ENGINE - LP COMPRESSOR - PROVIDE LONGER ATTACHING BOLTS FOR THE OPEN LATCH INDICATOR
BRACKET - CATEGORY CODE 6 - MOD.ENG-72-0175

V2500-ENG-72-0175

SERVICE BULLETIN

Replacement of the Bolts
Fig.1

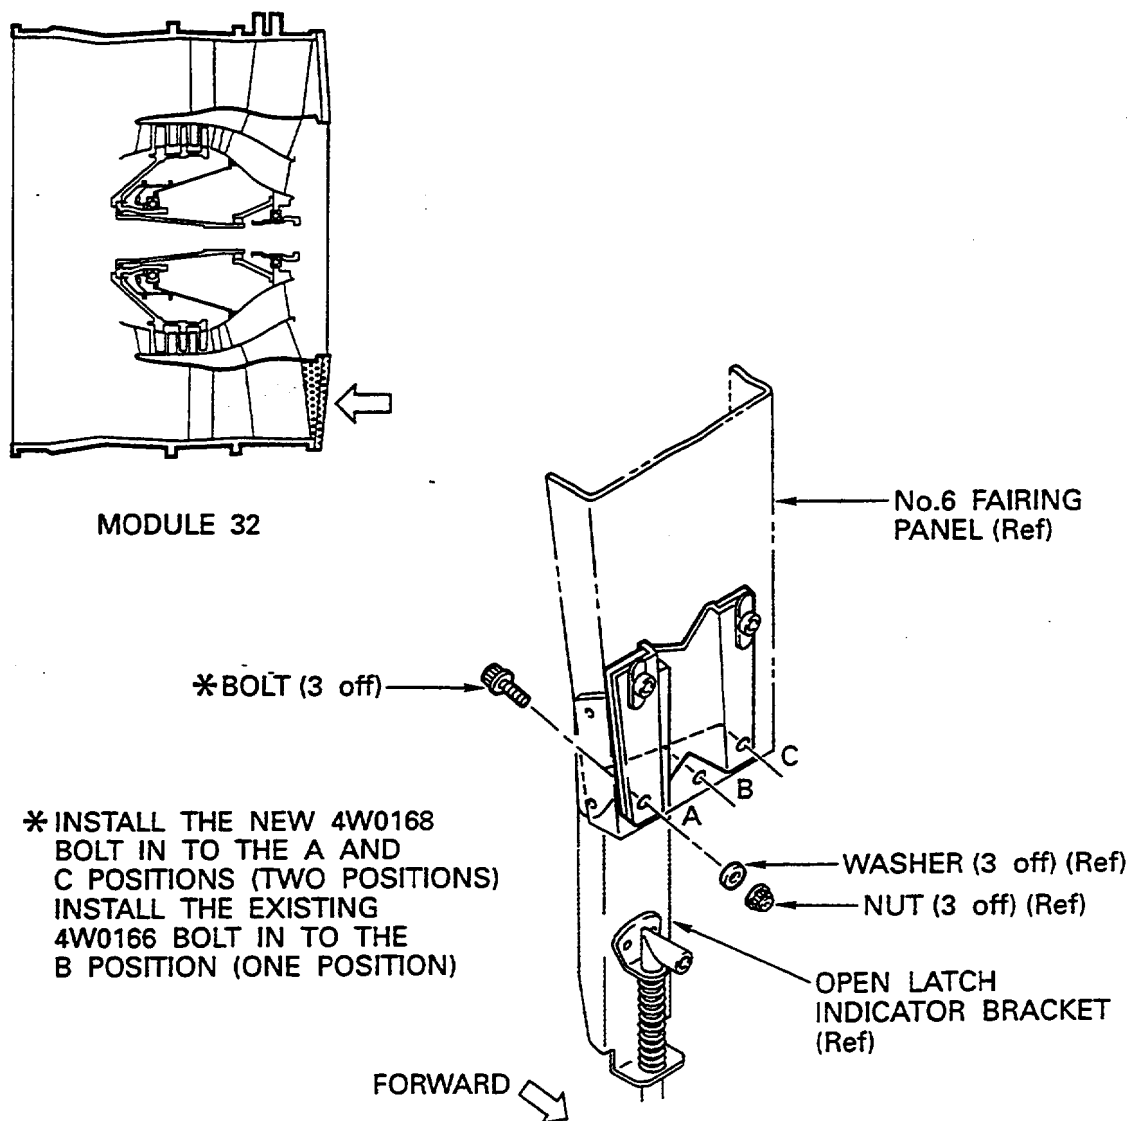
The length of existing bolts that secure the No.6 fairing panel and the open latch indicator bracket may not be of sufficient length.

Insufficient bolt length may occur as a result of adverse tolerances.

- (1) The length of two 4W0168, bolts (At both ends of No.6 fairing panel) in the three relate bolts which attach the open latch indicator bracket to the No.6 fairing panel are changed (See Figure 1).

NOTE: The 4W0166, middle bolt is not changed.

- 1 Replace the existing two bolts with the new two 4W0168, bolts on both ends of the No.6 fairing panel at two positions (Refer to Figure 1).

NOTE: The existing middle position of 4W0166, bolt on the No.6 fairing panel is not changed.
